## **NHTSA RECALL 21V095**

### **AUTOCAR, LLC SAFETY RECALL ACX-2103**

Autocar has determined that the turbocharger heat shield may fail on certain Xpeditor vehicles.

This document provides instructions to replace the turbocharger heat shield.

*Figure 1*

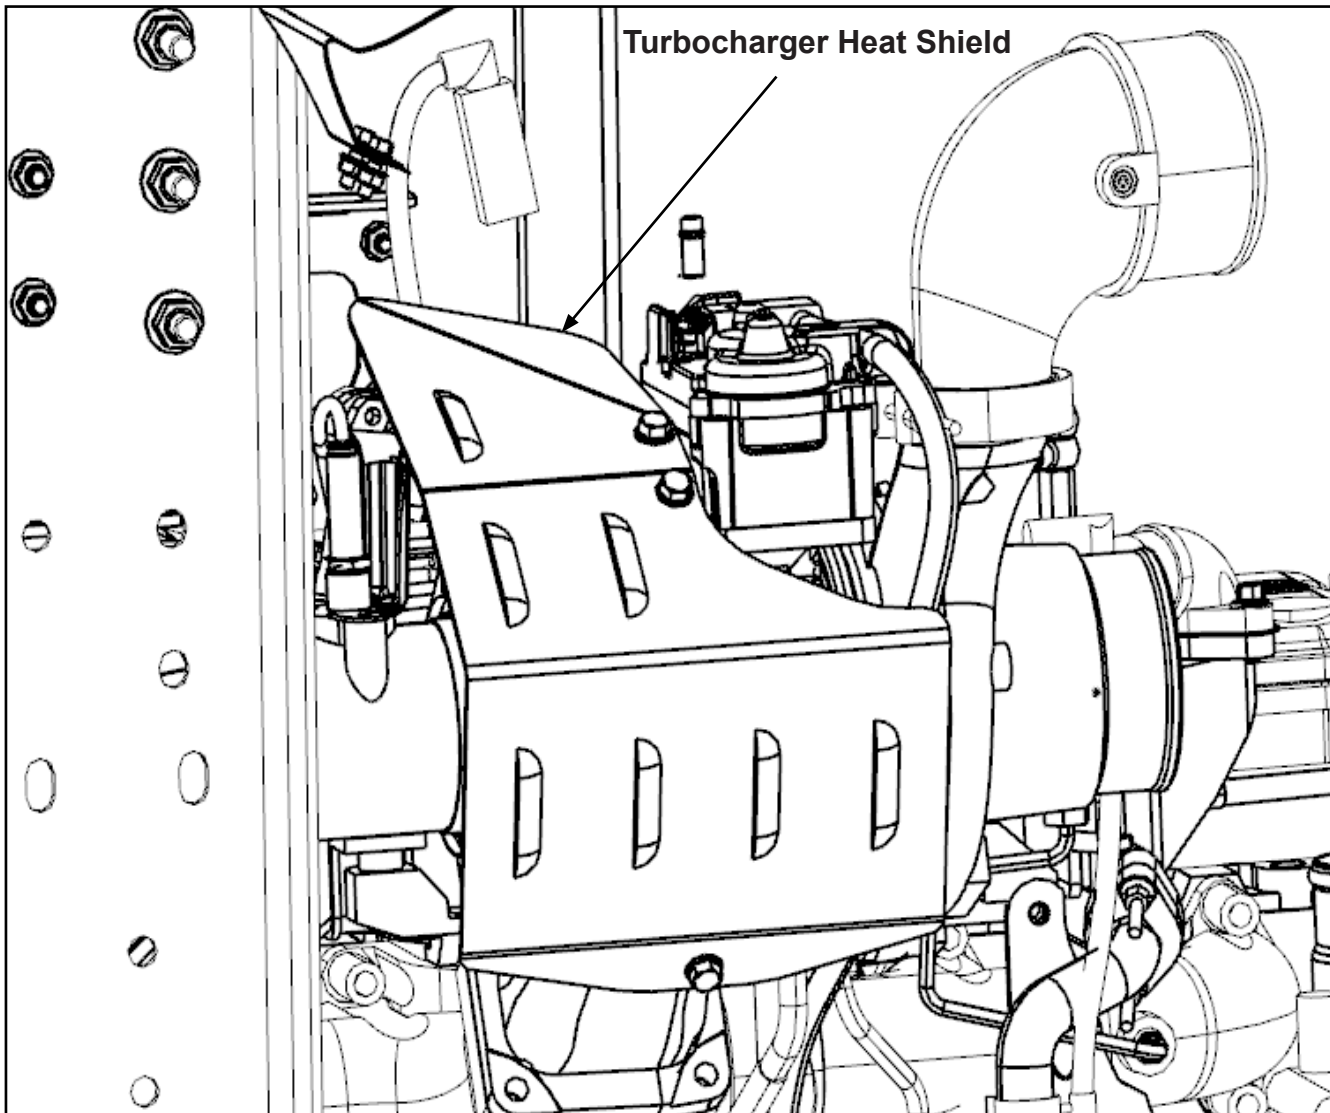
3. From the right side of the truck, locate the turbocharger heat shield (see *Figure 1*).

**Figure 2**

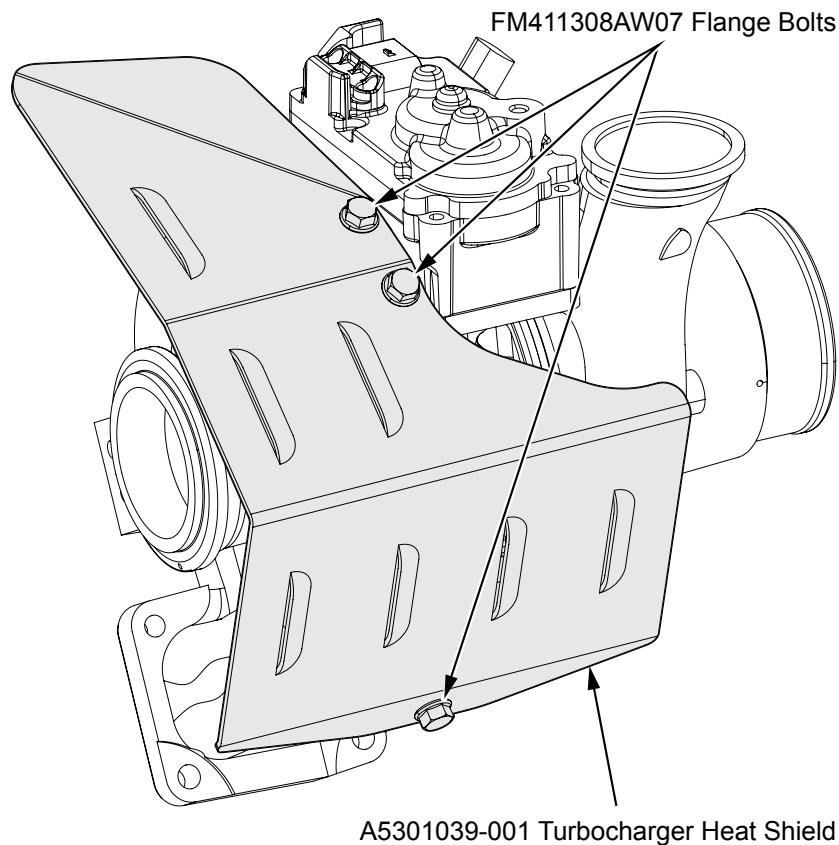
**Note:** The turbocharger heat shield may have experienced fatigue failure do to excessive vibration and may not be present.

4. Remove and discard the turbocharger heat shield and fasteners.
5. Apply medium strength thread lock (obtained locally) to (3) (FM411308AW07) flange bolts and install the (A5301039-001) turbocharger heat shield. Tighten the bolts to 25 +/-2.5 lbs.-ft. of torque (see Figure 2).
